MPL2013-00019

AGENDA ITEMS 1.A. ■ LAKE NONA TOWN CENTER- PHASE 1 SPMP AMENDMENT

SUMMARY

exhibit 2.2

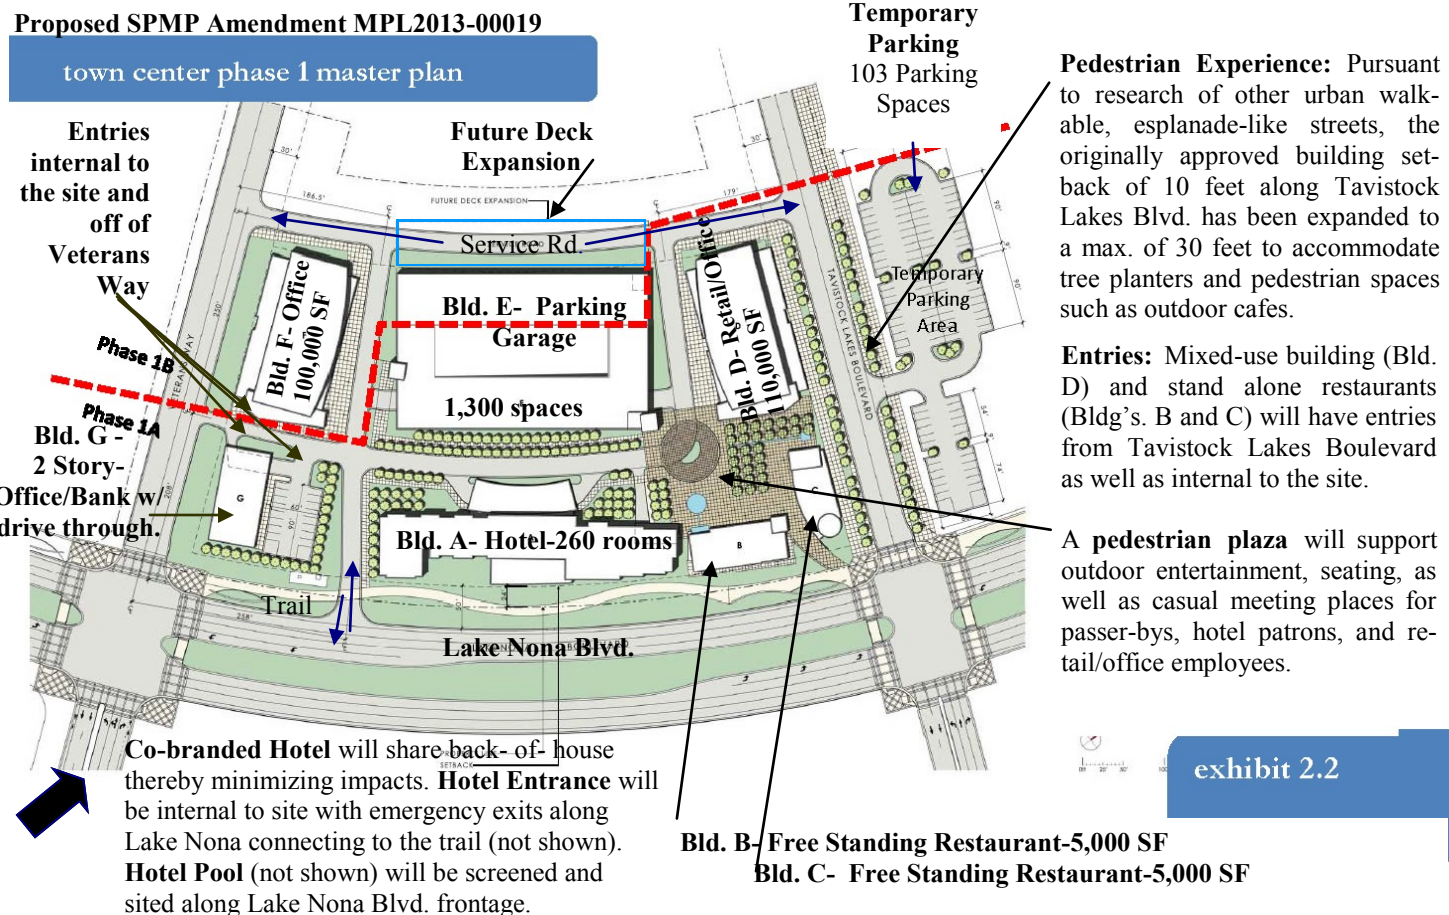
As shown in revised Exhibit 2.3, the site will have an interconnected sidewalk system allowing free movement of pedestrians across the site. Per Section 68.323(a), connecting walkways should be grade separated from the Building G parking lot, with a paved surface a minimum of 6 feet in width.

17. GENERAL SITE PLAN REVISIONS (EXHIBITS 2.2 AND 2.3) TO BE SUBMITTED AS PART OF APPEARANCE REVIEW

- i. All building setbacks and the total number of Building G parking spaces;
- ii. Dimensions of all on-site pedestrian pathways, plaza, parking spaces, drive aisles and landscaping areas pursuant to LDC Sections 61.311-314.
- iii. Crosswalks should be added along the northern pedestrian path and at project exit along Lake Nona Boulevard.
- iv. Phasing plan showing that each phase can stand alone as it concerns parking;
- v. Cross-sections of Tavistock Lakes Boulevard and Veterans Way shall be consistent with SUB2011-00032 and detail enhanced pedestrian pathways; and
- vi. Description of the hotel service areas, nature and extent of pool screening with additional written description on how all these uses will function shall also be provided.

- i. FAR: A FAR of 1.16 is allowed consistent with the development plan shown on Exhibit 2.2.
- ii. SETBACKS: The following building setbacks are permitted along the following roadways:
 - Tavistock Lakes Boulevard: Maximum 30 ft. from back of curb.
 - Veterans Way: Maximum 30 ft. from back of curb.
 - Lake Nona Boulevard: Maximum 24 ft. from the property line.

exhibit 2.5

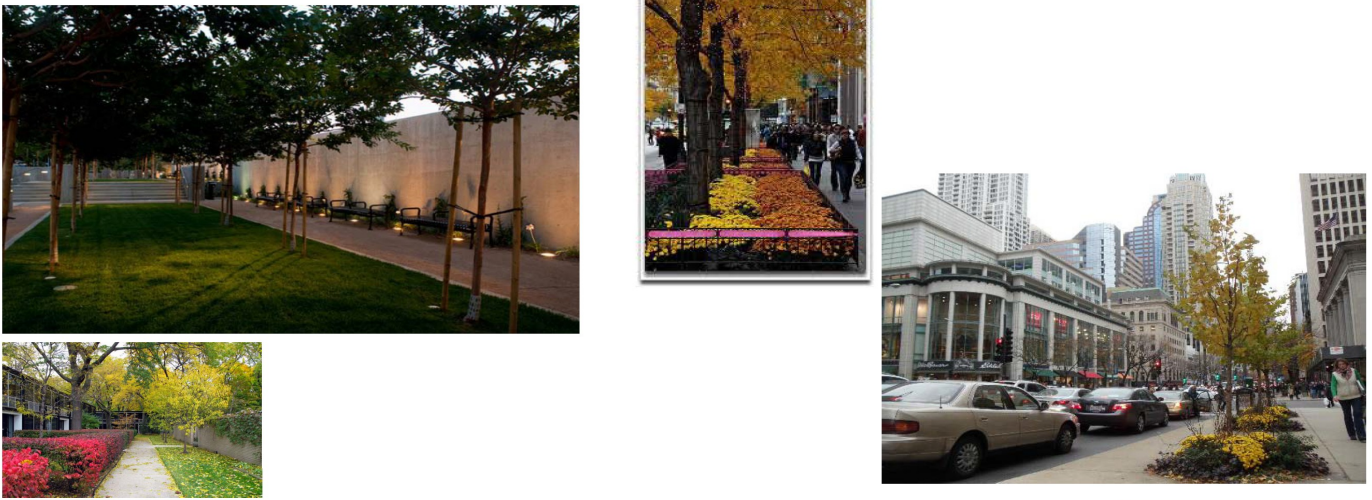
Note: The imagery shown above is intended to depict the vision for the pedestrian corridor along the parking garage and Tavistock Lakes Boulevard within the Lake Nona Town Center Phase 1 project. It is not an indication of a specific landscape plan.

Sections of the Survey and the Preliminary Plat (SUB2011-00032)

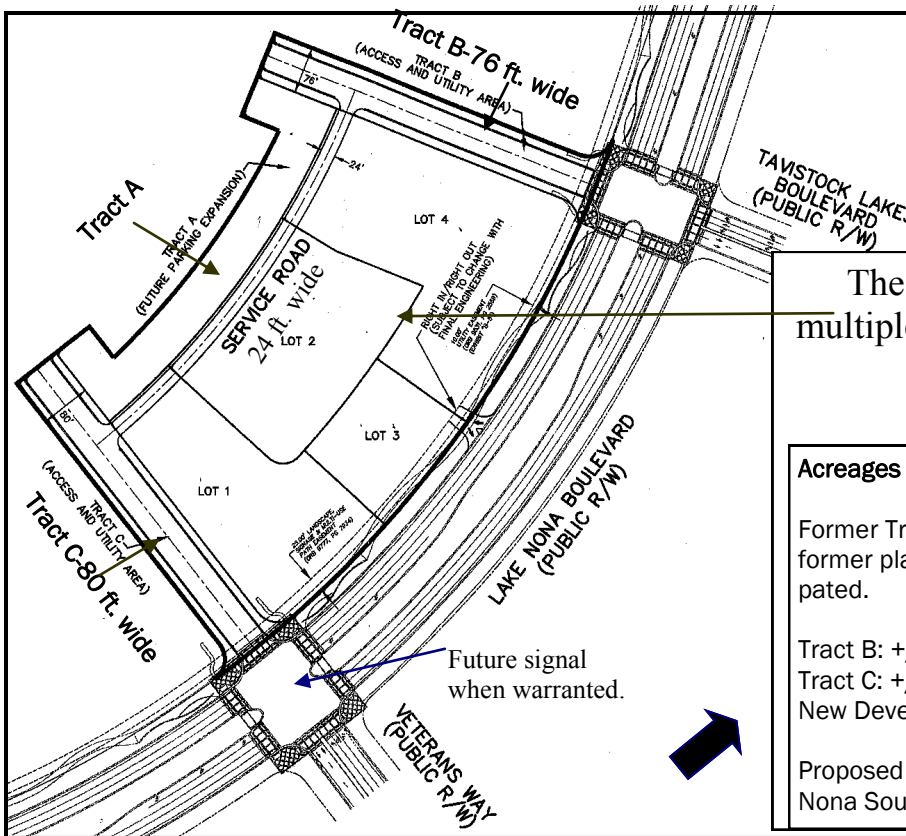
The previously approved plat with multiple lots will be revised to reflect the single lot SPMP amendment.
